Safety Evaluation Report

**Related to the License Renewal
of Prairie Island Nuclear
Generating Plant Units 1 and 2**

Docket Nos. 50-282 and 50-306

**Northern States Power Company, a Minnesota
Corporation (NSPM)**

Figure 4.3-2

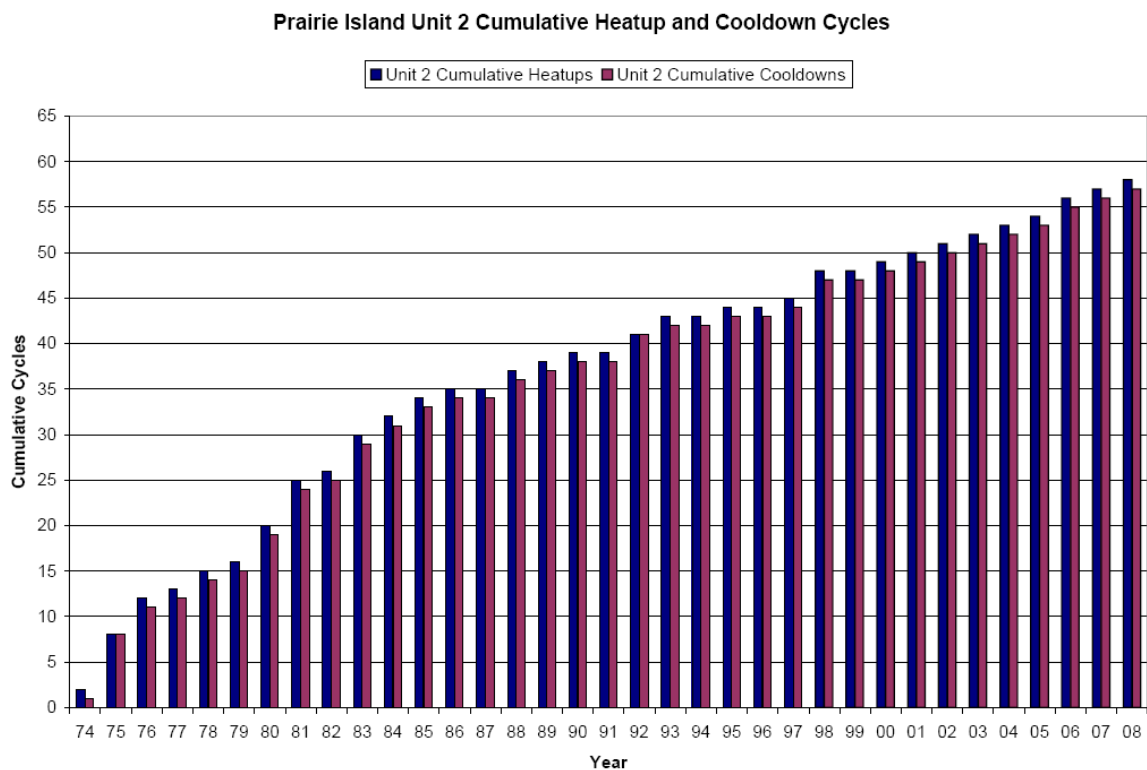
4.3-2, that the slope used by the applicant for making cycle projections is significantly greater than that of the average of the past 25 years. As expected, the slopes of event occurrence (i.e., the rates) during the first few years (5 to 7 years) are higher than the averages for both heatups and cooldowns. This means that the basis of projections that the applicant used is conservative and therefore, the staff found it to be acceptable.

Based on its review, the staff's concern on the transient event monitoring is resolved because the applicant provided the information requested and the information validates the PINGP fatigue management program and the applicant's assumption for the number and severity of transients.
